**RE: Town of Kittery, Planning Board Services
523 US Route 1, Aroma Joe's Site Plan Review Application
Tax Map 66, Lot 26; Mixed Use (MU) Zone
CMA #591.139**

Re: Kittery Aroma Joes | Site Plan Peer Review Comments

Haley Ward, Inc. (Haley Ward) has prepared the following response to the review comments on the 523 US Route 1 Aroma Joes development, provided by Jodie Strickland (CMA Engineers) on April 19, 2022. The comments have been provided in bold italics, followed by our response.

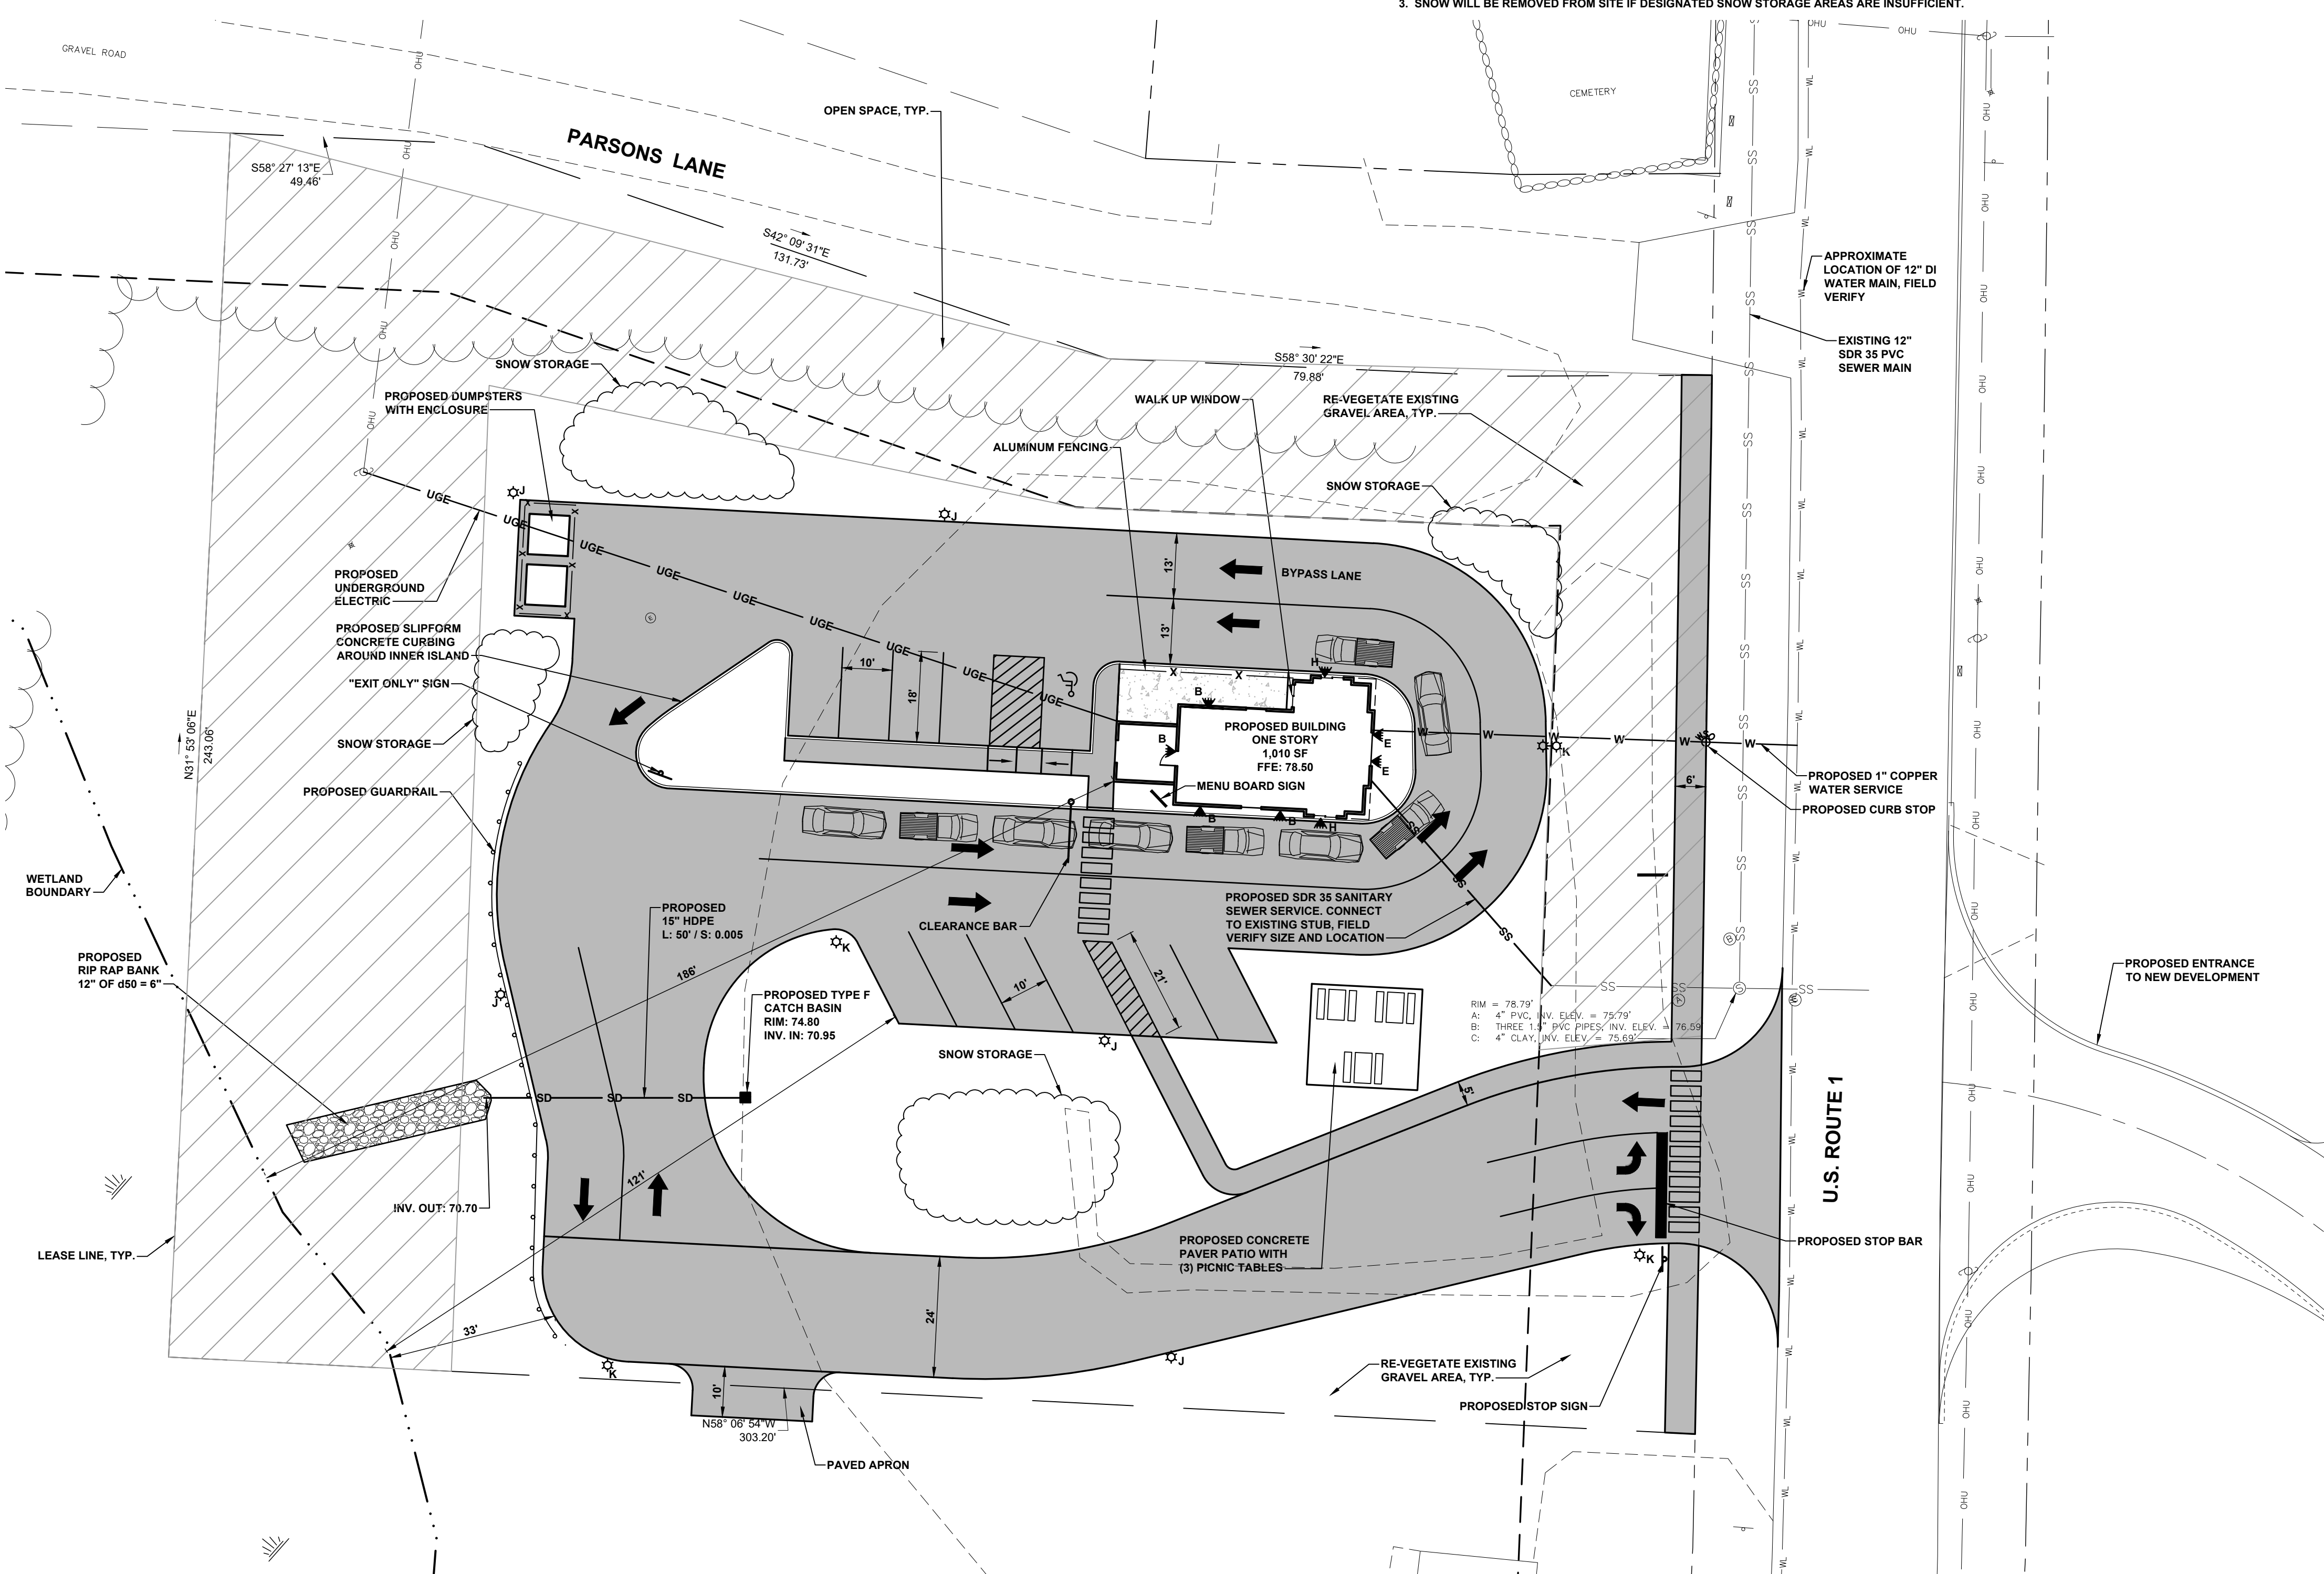
16.9.3.1. The plan identifies wetlands. Site development and disturbance appears to avoid the setbacks associated with the wetlands however, the proper setbacks should be indicated on the plan.

The size of the wetland is not indicated but based on the setbacks shown it is assumed that it is larger than 1 acre in size. The applicant has shown the provided setbacks for the building (100' from a wetland > 1 acre) and the driveway (30' from a wetland > 1 acre) however, there are no parking area setbacks shown on the plans. The setback from a wetland greater than 1 acre for a 6-10 stall parking area without BMPs is 100', it appears that the southern-most parking area may be within the 100' setback. Please clarify.

10. **The plan identifies wetlands. Site development and disturbance appears to avoid the setbacks associated with the wetlands however, the proper setbacks should be indicated on the plan.**

11. **The size of the wetland is not indicated but based on the setbacks shown it is assumed that it is larger than 1 acre in size. The applicant has shown the provided setbacks for the building (100' from a wetland > 1 acre) and the driveway (30' from a wetland > 1 acre) however, there are no parking area setbacks shown on the plans. The setback from a wetland greater than 1 acre for a 6-10 stall parking area without BMPs is 100', it appears that the southern-most parking area may be within the 100' setback. Please clarify.**

These setbacks have been added to the plans.

The parking area on the south side of the building is approximately 120' away from the wetland; this setback has been added to the plan.

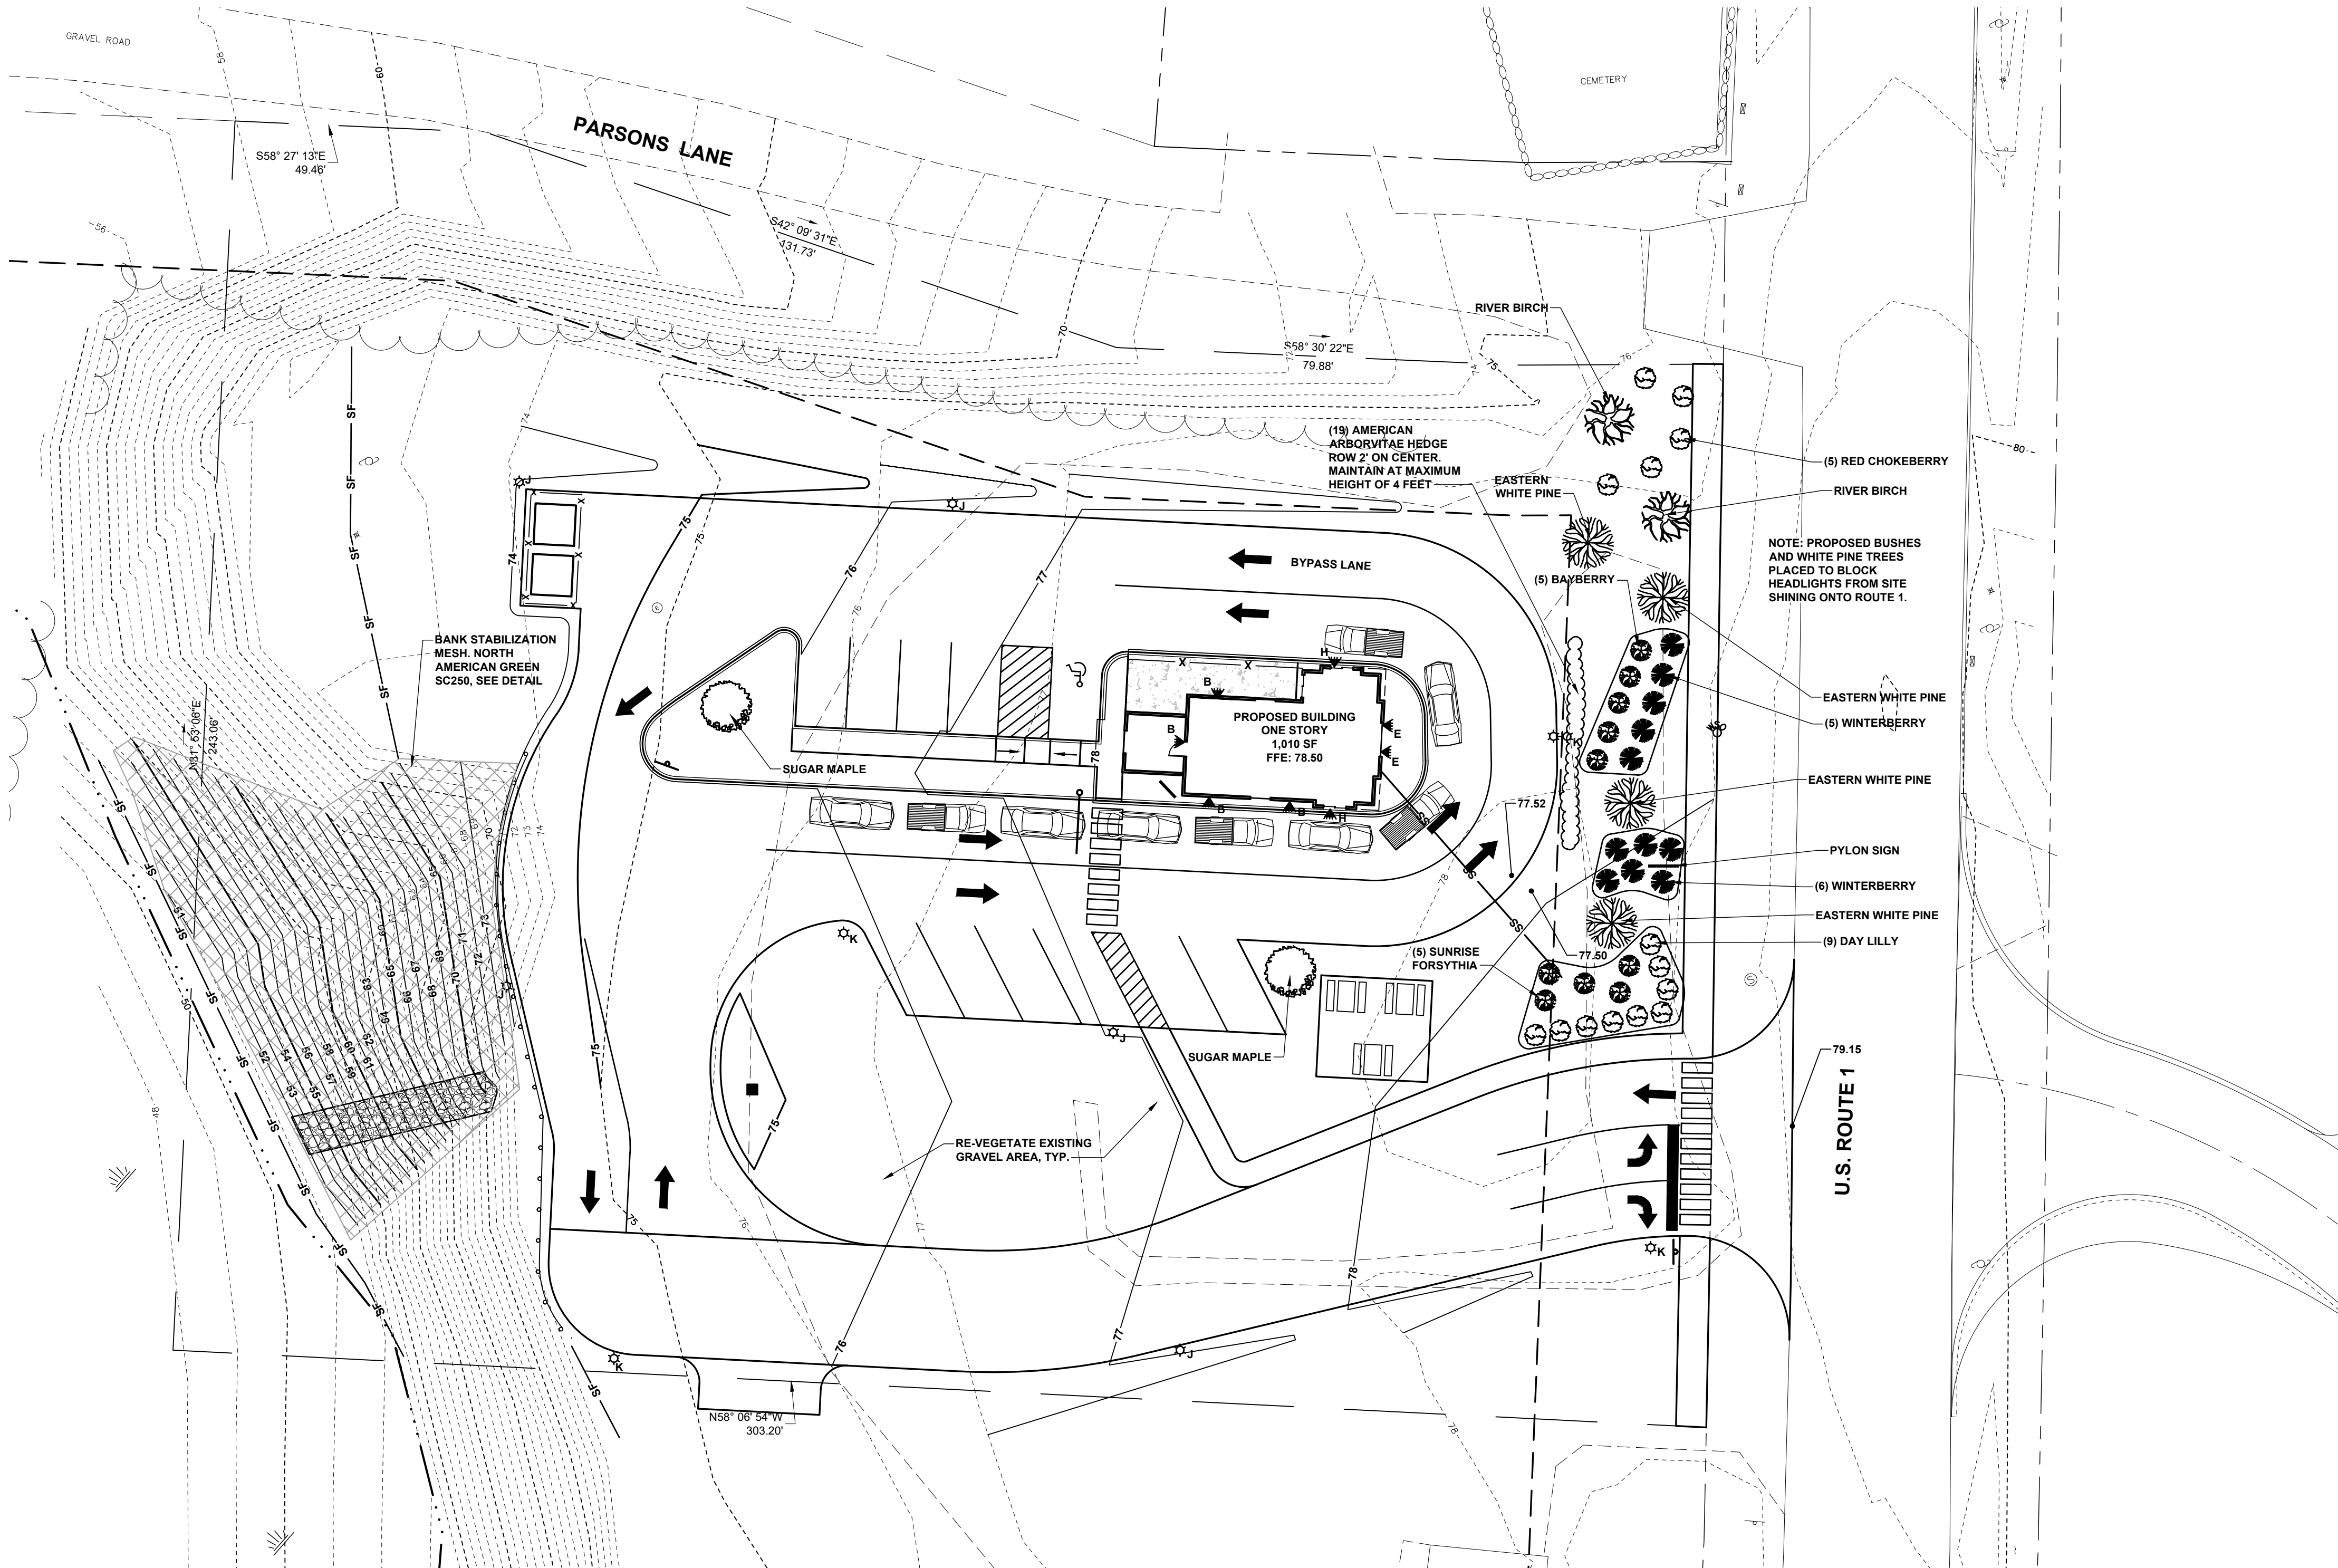
The applicant should indicate how the project is proposed to be constructed in accordance with these recommendations. If the possibility of increased pavement maintenance remains, that should be noted on the plan and may be a condition of approval. If the existing steep slope is not flattened, the applicant should describe how it will be maintained.

The applicant should indicate how the project is proposed to be constructed in accordance with these recommendations. If the possibility of increased pavement maintenance remains, that should be noted on the plan and may be a condition

of approval. If the existing steep slope is not flattened, the applicant should describe how it will be maintained.

The existing slope at the southwest corner of the site has been flattened as much as possible while avoiding encroachment on the adjacent wetland. This slope will also be stabilized with erosion control matting as shown on the drawings.

TYPICAL ROADWAY/SIDEWALK BUILDUP DETAIL
N.T.S.

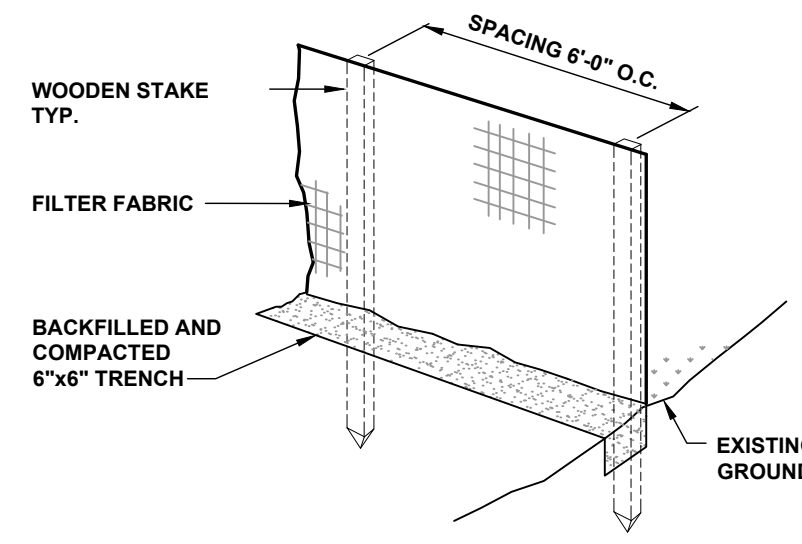
Discussion of sidewalk installation was part of the MDOT scoping meeting and consequently, the applicant has added a proposed sidewalk on site. Details of the sidewalk should be provided.

- 2. Discussion of sidewalk installation was part of the MDOT scoping meeting and consequently, the applicant has added a proposed sidewalk on site. Details of the sidewalk should be provided.***

A detail of the proposed sidewalk has been provided on the Detail Sheet.

TYPICAL WATER SERVICE DETAIL
N.T.S.

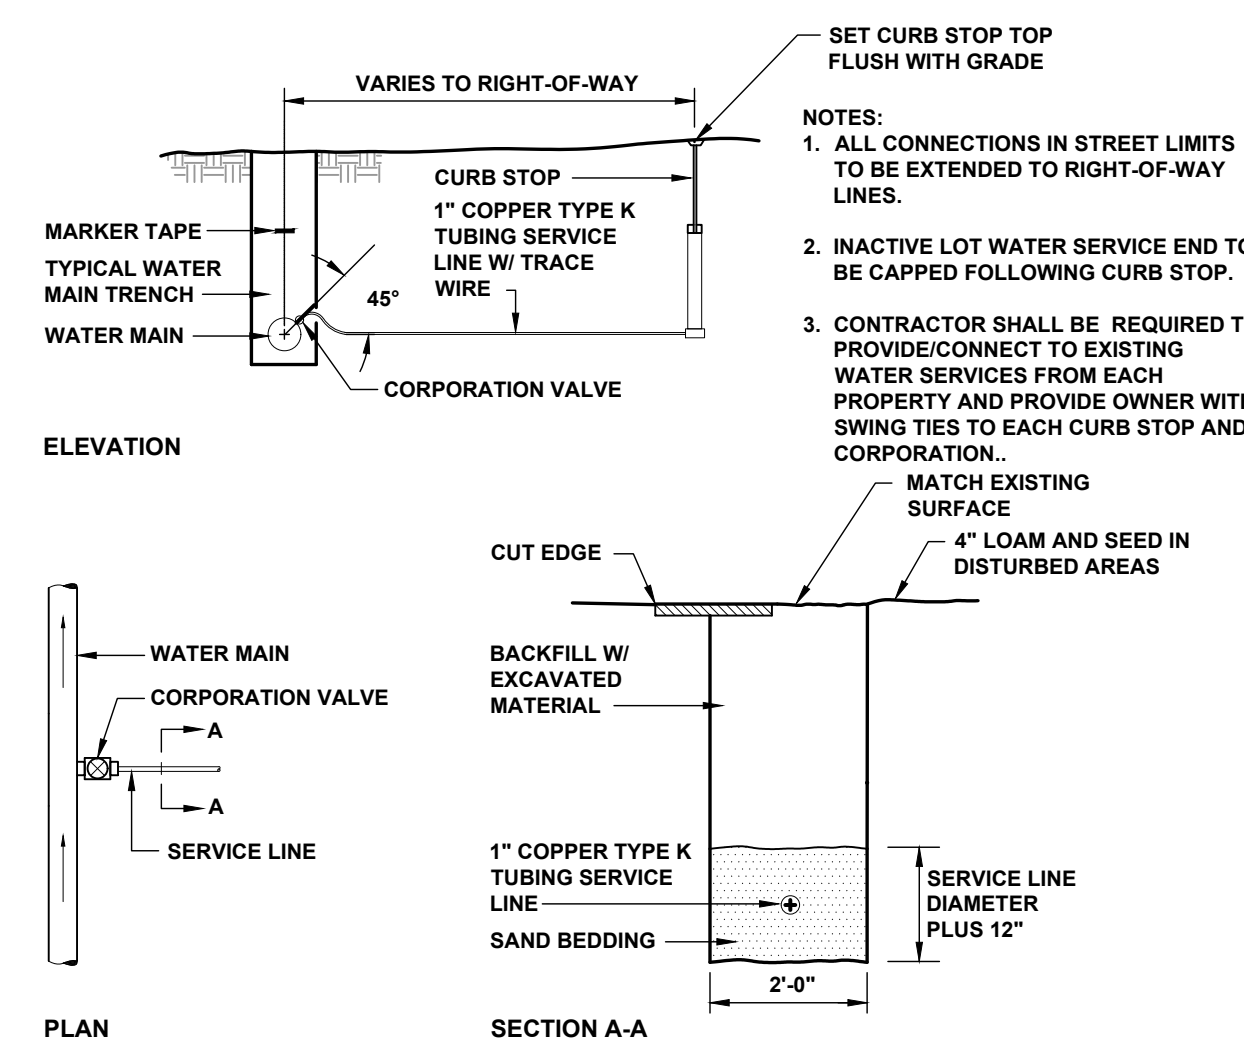
The plans should provide details for the water service (size, material, bedding, curb stop, etc.)

- 3. The plans should provide details for the water service (size, material, bedding, curb stop, etc.)***

A detail of the proposed service has been provided on the Detail Sheet.
